ADDENDUM TO THE CONTRACT DOCUMENTS	Page Number 1	No. of Pages 5
Addendum No. Two (2)	Date Addendum Issued: September 28, 2017	
Issuing Office Division of Parks and Outdoor Recreation 550 West 7 th Ave., Suite 1380, Anchorage, Alaska 99501 Phone: 269-8731 Fax: 269-8907	Previous Addenda Issued Two (2)	
Project: Eagle Rock KRSMA Facility Improvements Project No.: 78036-3	Date and Hour of Quotes Due October 3, 2017 at 2:00 PM prevailing time

EAGLE ROCK KRMA
FACILITY IMPROVEMENTS
PROJECT No. 78036-3

PILE DETAILS & PLAN

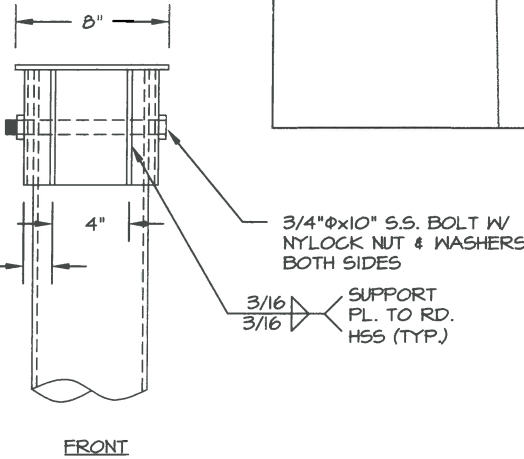
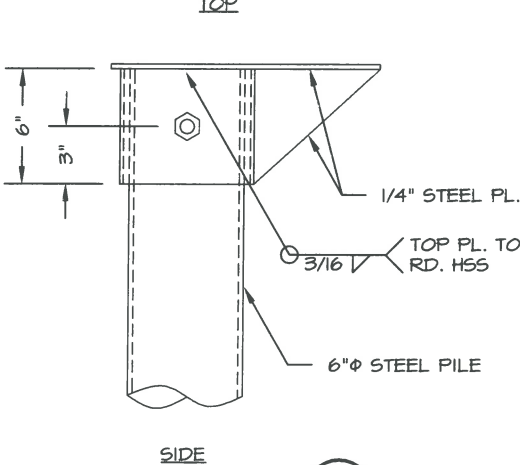
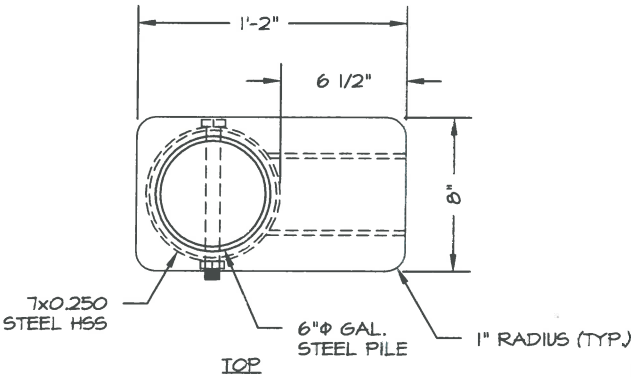
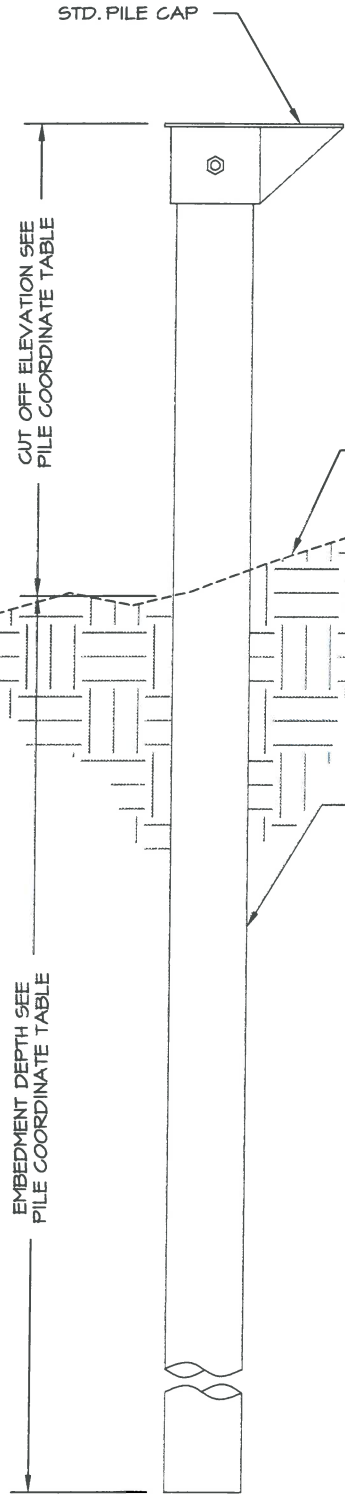
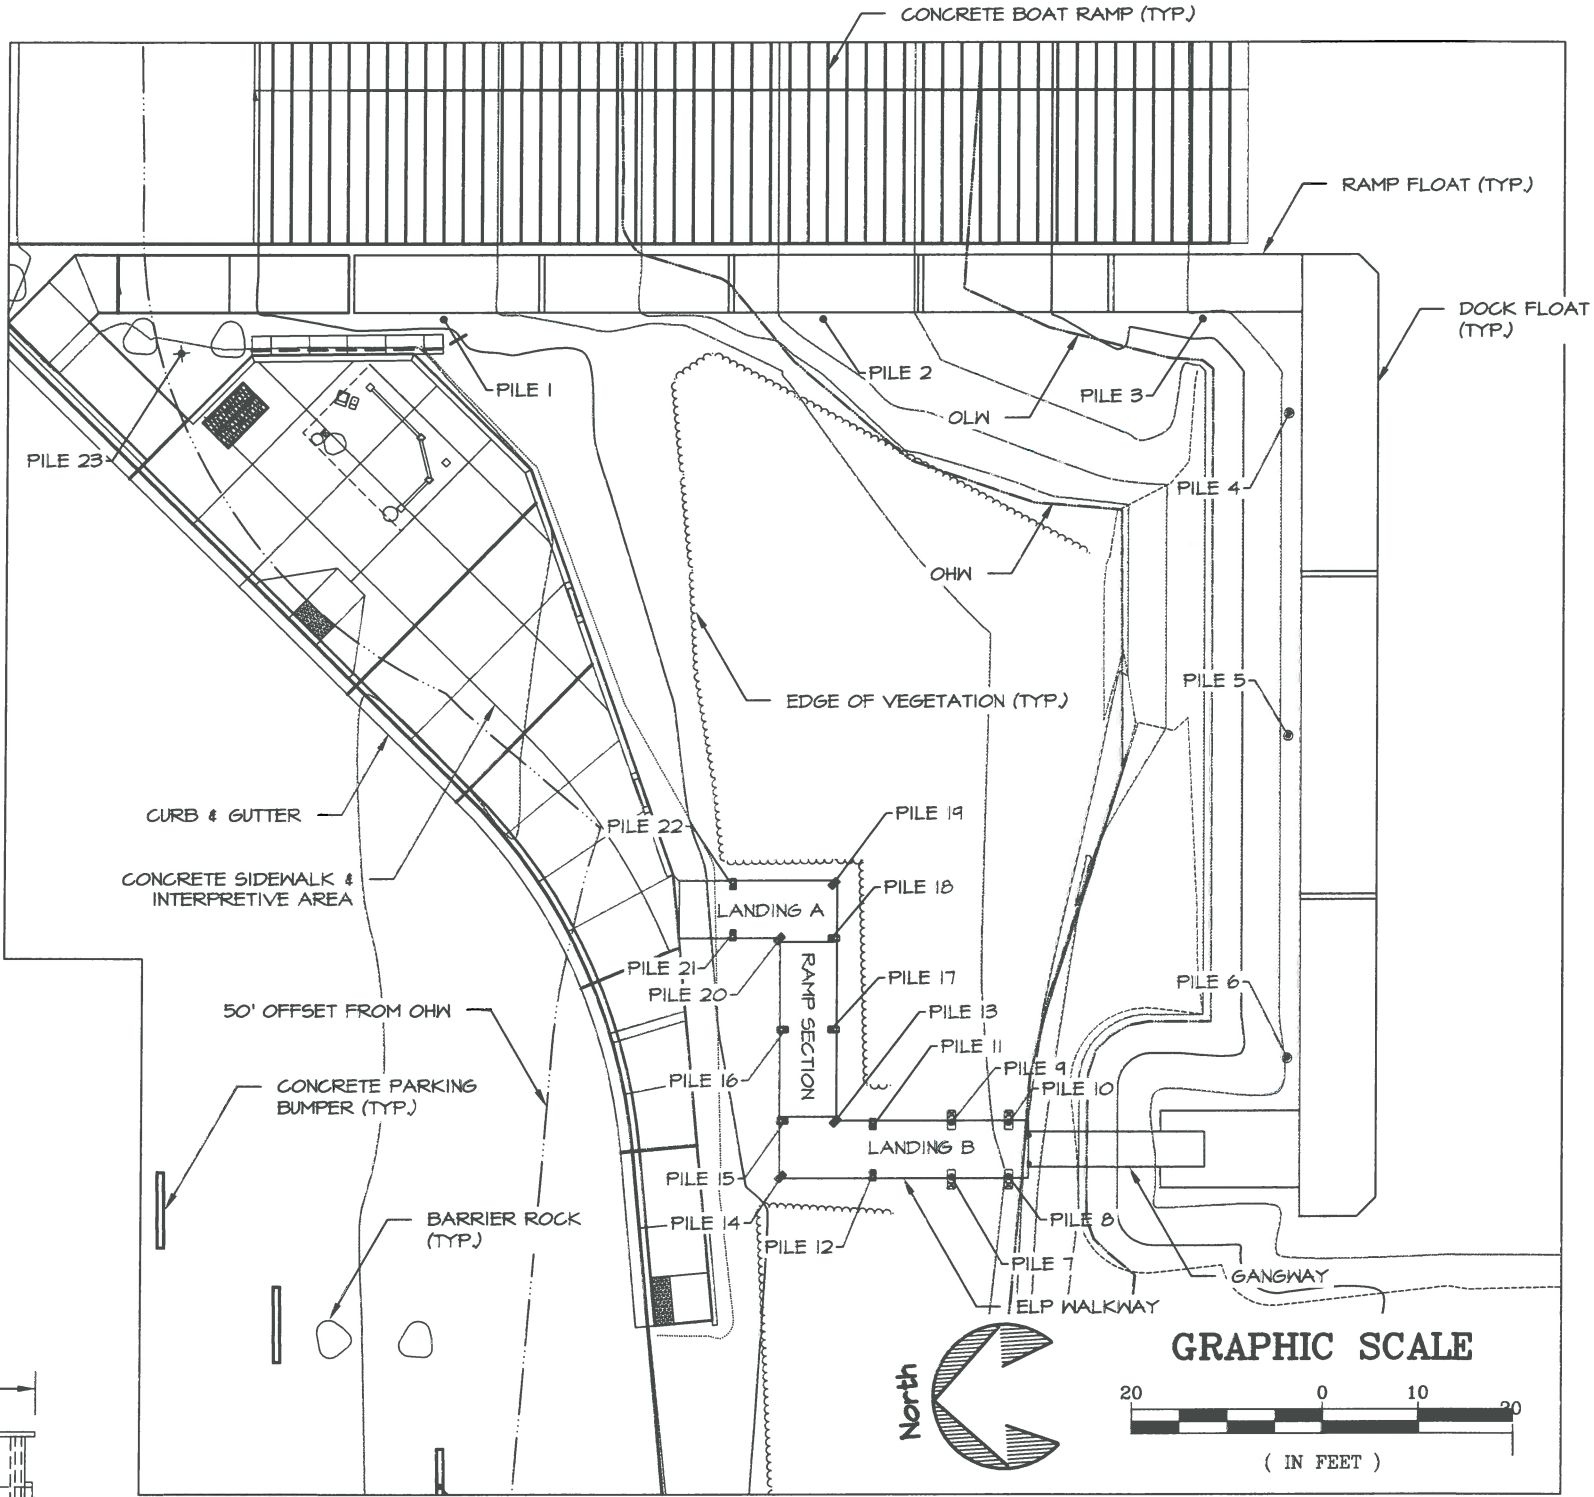
Replace sheet 21 of the Drawings with Addendum No. 2 - Attachment B (1 page)

RECORD OF REVISIONS			
NO.	ADDENDUM	DATE	DESCRIPTION
1	2	9/28/2017	REPLACE "ASTM A500 GRADE B" TO "SEE PAGE S1.0"

SEE PAGE S1.0
6 INCHES
STANDARD WEIGHT
GALVANIZED (ASTM A123)
